NORTH FALLS

Offshore Wind Farm

Outline Construction Traffic Management Plan (~~Clean~~Tracked)

Document Reference: 7.16
Volume: 7
Date: ~~April~~July 2025
Revision: ~~4~~3

Drawing 104560-MMD-00-XX-DR-CE-1070_Rev01

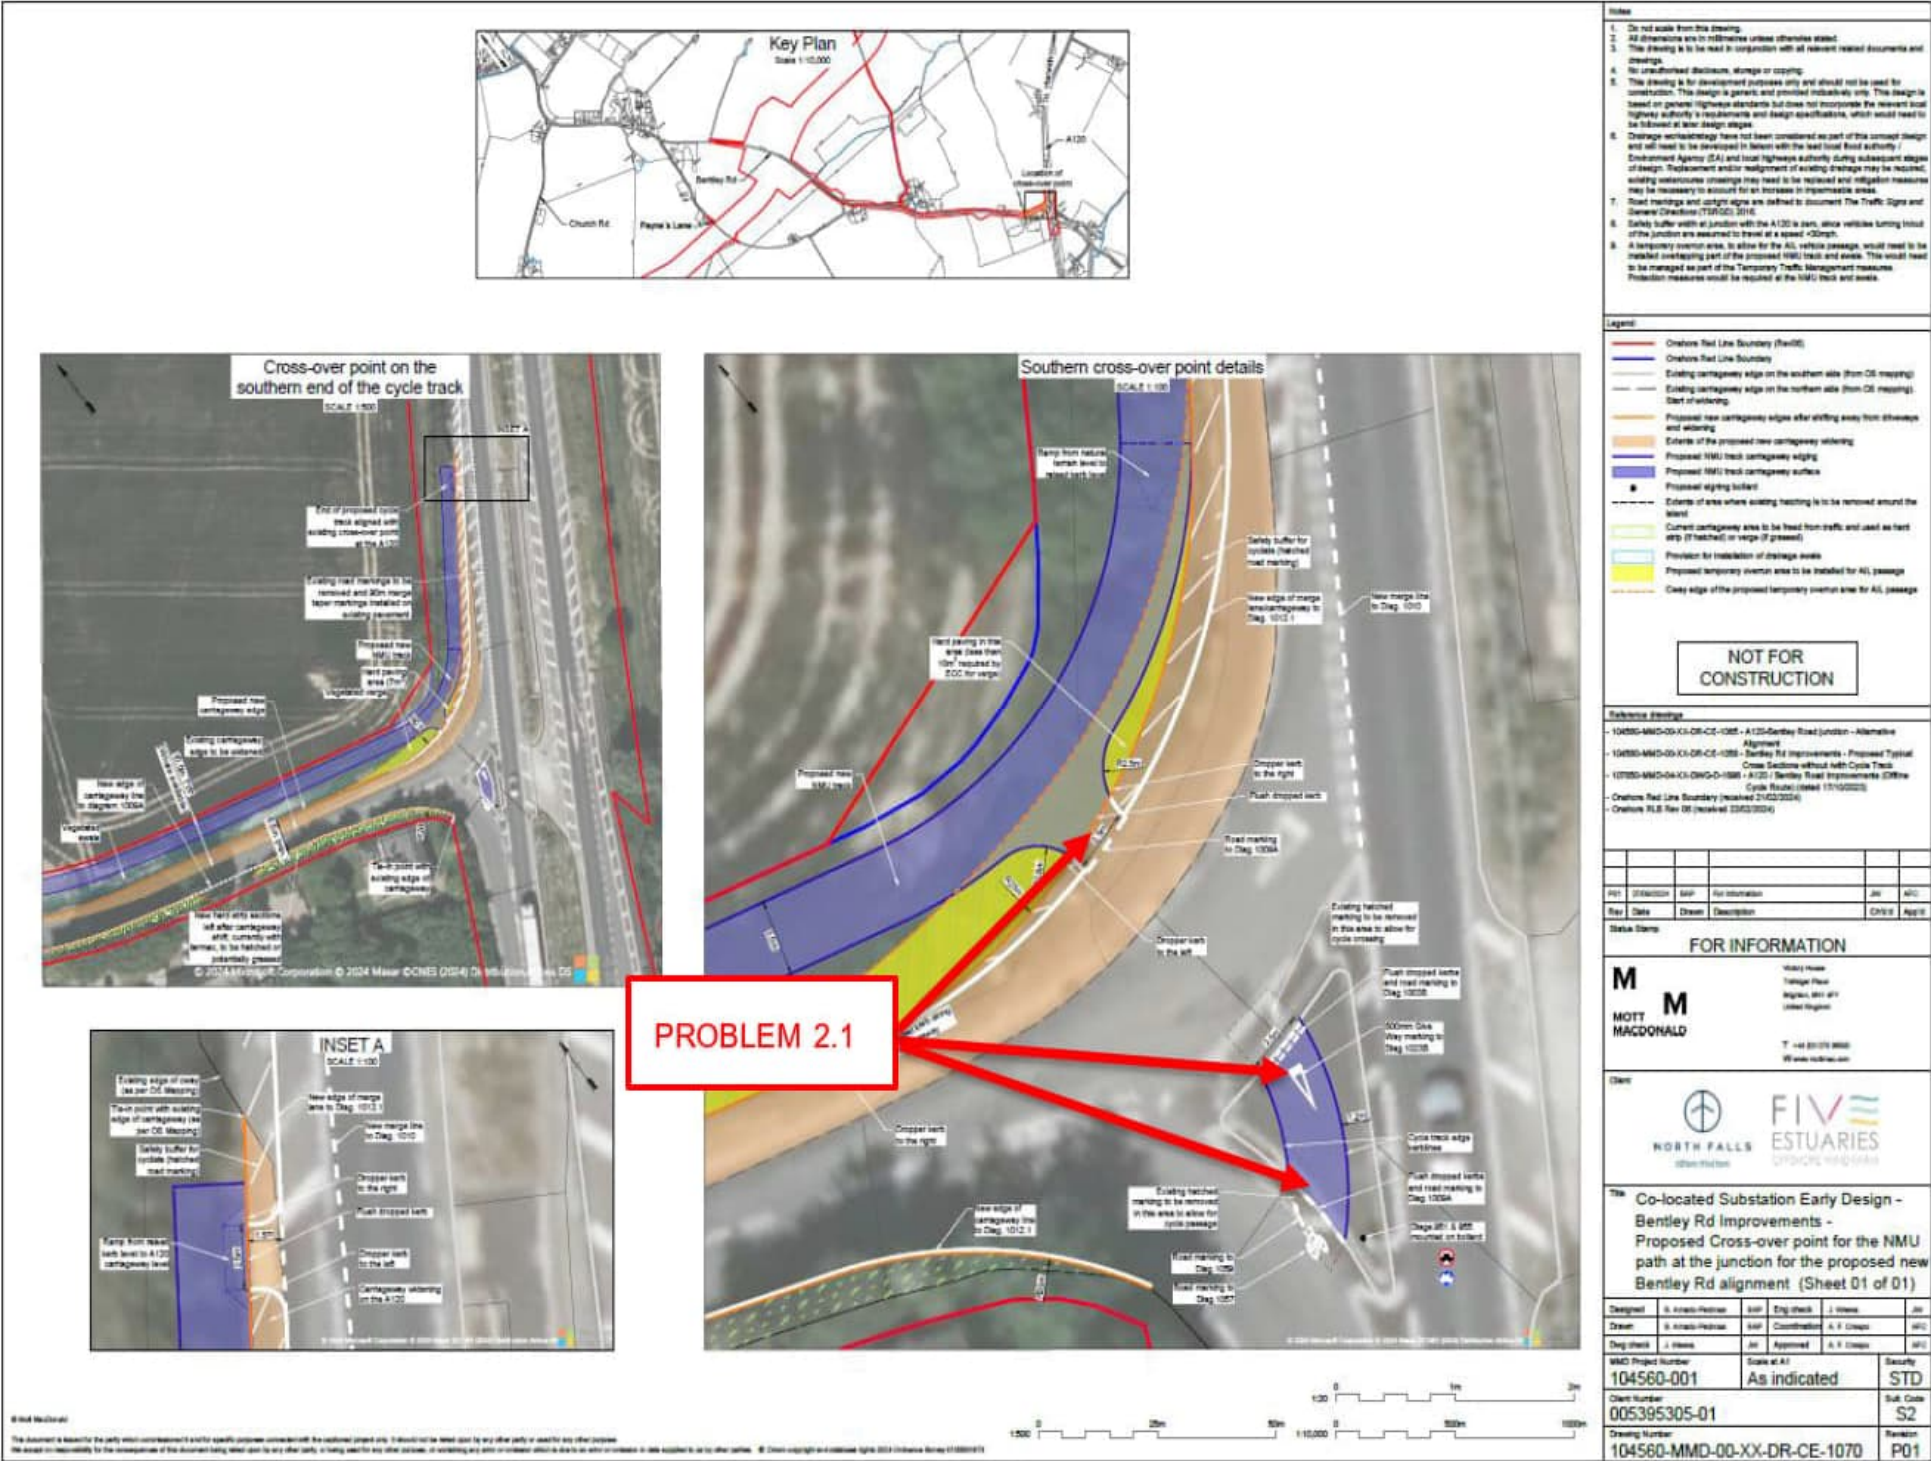
Drawing 104560-MMD-00-XX-DR-CE-1070_Rev01						
2.1	Location: A120/Bentley Rd Junction. Summary: Lack of hazard warning tactile paving provided at dropped kerbs leading to the NMU route may lead to collisions between NMUs and vehicular traffic. Design drawings show an extension of the NMU route adjacent to the A120. An existing splitter island will be amended with dropped kerbs and road markings to allow NMU users to leave the A120 Northwest bound. This design is not shown complete with hazard warning tactile paving that would alert NMUs particularly those with visual impairments that they are about to enter the vehicular carriageway. This arrangement may in turn lead to collisions between NMUs and vehicular traffic.	It is recommended that any access points to the vehicular carriageway are provided with the appropriate tactile paving installations.	● RSA problem acknowledged but recommendation partially dismissed due to the crossover movement only being allowed to northbound cycles and cycle access points to/from the carriageway not requiring the installation of tactile pavement. ● To provide greater clarity to the crossing movements allowed at this crossover point and to improve safety, both for pedestrians and cycles, a segregated shared use section of the NMU track is to be added along the area of concern to direct pedestrians away from the crossover. Tactile pavement is to be installed at the start and end of this segregated shared use section of the NMU track, in line with the Department for Transport document: <i>Guidance on the Use of Tactile Paving Surfaces</i>, Section 5. Ladder tactile pavement shall be installed at the start/end of the pedestrian way within the NMU track for a depth of 2.4m each, and width of 1.5m (width of the pedestrian way). Tramline tactile pavement shall be installed at the start/end of the cycle way within the NMU track for a depth of 2.4m each, and width of 2m (width of the cycle way). The ladder and tramline tactile pavement will assist vision impaired people. Diagrams 956 & 957 mounted on bollards and installed at the start/end of the segregated shared use section of the NMU track would also assist all other users. The installation of Diagrams 956 & 957 is a recommendation within <i>Guidance on the Use of Tactile Paving Surfaces</i>, Section 5 and LTN 1/20 paragraph 9.4.3, however their installation shall be discussed with the ECC LHA to avoid sign clutter. ● The segregated shared use NMU track will direct pedestrians away from the crossover point at the junction, greatly reducing the risk of pedestrians trying to cross. ● It is also proposed that the carriageway at the cycle area of the segregated shared use NMU track is surfaced in a different colour than the rest of the NMU track, to make it more conspicuous to all users. ● Additionally, the corner radii at the NMU track leg leading to the trafficked carriageway have been reduced to R=1m and the leg width, to 2.5m, except at the corner radii, to reduce comfort at making the turn. Edge of lane road markings have been proposed at the intersection of this leg with the NMU mainline cycle track and directional arrow road markings to emphasize the one-way character of this cycle track leg. ● This matter will be appraised further, in conjunction with the Local Highways Authority, as an integral part of the detailed design process, when bespoke signing and road marking drawings and specifications are to be agreed and produced for the preferred solution.	To be populated by the Audit Team	To be populated by the Client / Project Sponsor	This matter will be appraised further, in conjunction with the Local Highways Authority, as an integral part of the detailed design process, when bespoke signing and road marking drawings and specifications are to be produced for the agreed preferred solution. All measures to increase safety, described at the Design Organisation Response column, to be added to drawing 104560-MMD-00-XX-DR-CE-1070_Rev02.
